MCF5485 Chip Errata

Silicon Revision: All

Supports: MCF5480, MCF5481, MCF5482, MCF5483, MCF5484, and MCF5485

Summary of MCF548x Errata

Figure 1. PCI bus 2-beat transfer

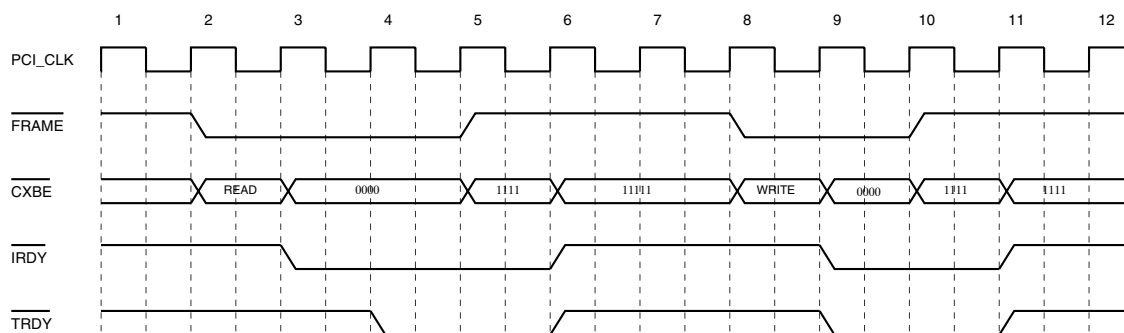
Description: As shown below, an unexpected 2-beat transfer is issued on the PCI bus when a Type 1 configuration PCI cycle is performed using the Configuration Mechanism and more than 3 bytes are being transferred. The byte enables are correctly driven, but a second false data transfer is issued.

For writes, there is no harm done other than one or more (if a disconnect occurs) wasted PCI cycles for the false data transfer. During reads, two beats of data, the good data and the false data, are pushed into an internal read data FIFO and only one is popped off the FIFO. The first 32-bit read completes as expected. Any read following this read, causes the transaction on the PCI bus as expected. However, internally the data returned for this next read is not new data but what remained in the FIFO from the first two-beat read, the second false data transfer. The addition of the false data in the read FIFO causes subsequent reads to be out-of-sync with the data in the FIFO.

Workaround: Only issue byte or 2-byte type 1 configuration reads. Addresses at byte offsets retrieve the correct bytes. This avoids the two-beat read transactions.

Workaround: Use the SPCPI RX interface to issue 32-byte type 1 configuration reads to PCI.

Workaround: After issuing a 32-bit type 1 configuration read via the configuration mechanism (using PCICAR), clear the read data FIFO of the false data by immediately issuing an XLB transaction that results in a master abort. For instance, after a type 1 configuration read (to bridge), change the bus number in the PCICAR to an unused bus and issue another type 1 configuration transaction (read or write). A read returns all 1s. The master abort status bits flag, PCISCR[MA] and PCIISR[IA]. If subsequent configuration reads across the bridge are needed, reprogram the bus number to the valid value and continue interleaving the master abort transaction between each.
